SEDC - DISPENSARY PHASE III

SOBOBA BAND OF LUISEÑO INDIANS
HORSESHOE PROPERTY DISPENSARY PHASE III
UTILITY PLAN
FOR: _____ W.O. _____ FILE NO. - _____

SHEET No. 4
OF 5 SHEETS

2026-05-26, ISSUED FOR BID

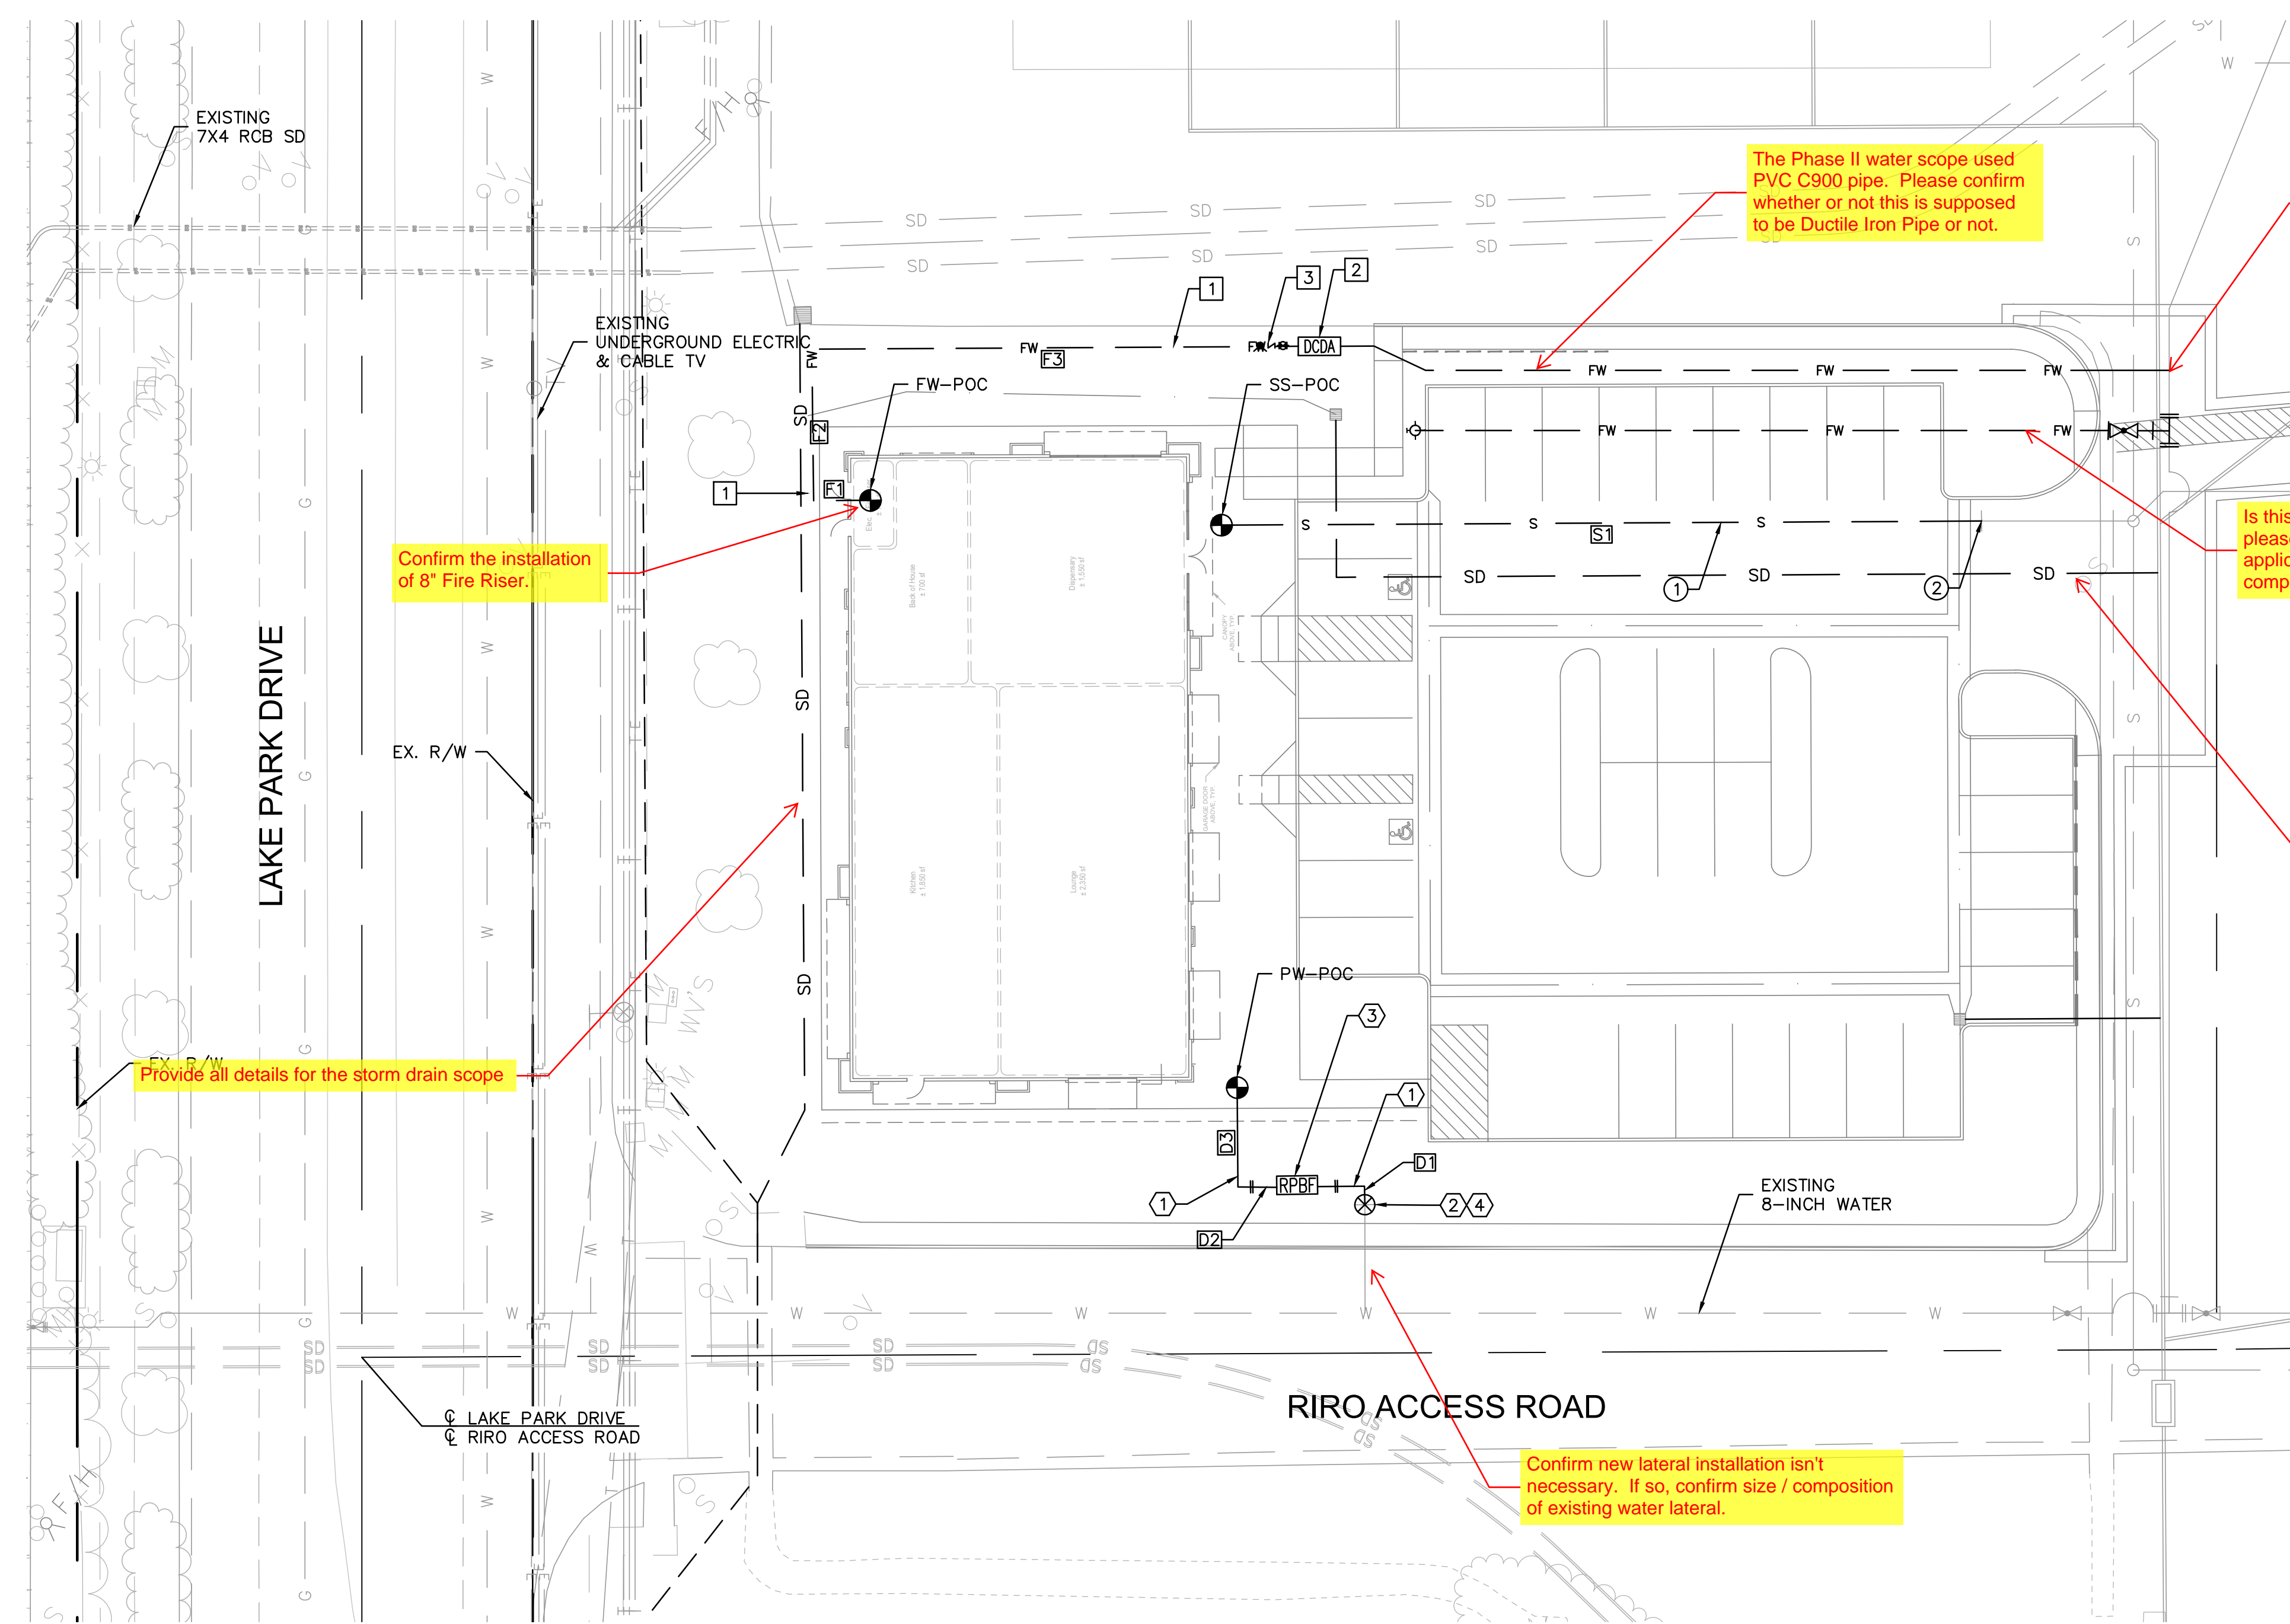
Is Phase III Precise Grading / Utility plan in a budgetary phase?

Confirm the installation of 8" Fire Riser.

The Phase II water scope used PVC C900 pipe. Please confirm whether or not this is supposed to be Ductile Iron Pipe or not.

Please provide the size and composition of the main the fire water lien is connected to.

Is this a new fire hydrant service? If so, please provide the necessary details: the applicable standards, the size and composition of the main its connected to.

Provide all details for the storm drain scope

Provide all details for the storm drain scope

Confirm new lateral installation isn't necessary. If so, confirm size / composition of existing water lateral.

PHASE III IS CURRENTLY ON HOLD. NO RESPONSE IF OFFERED AT THIS TIME.
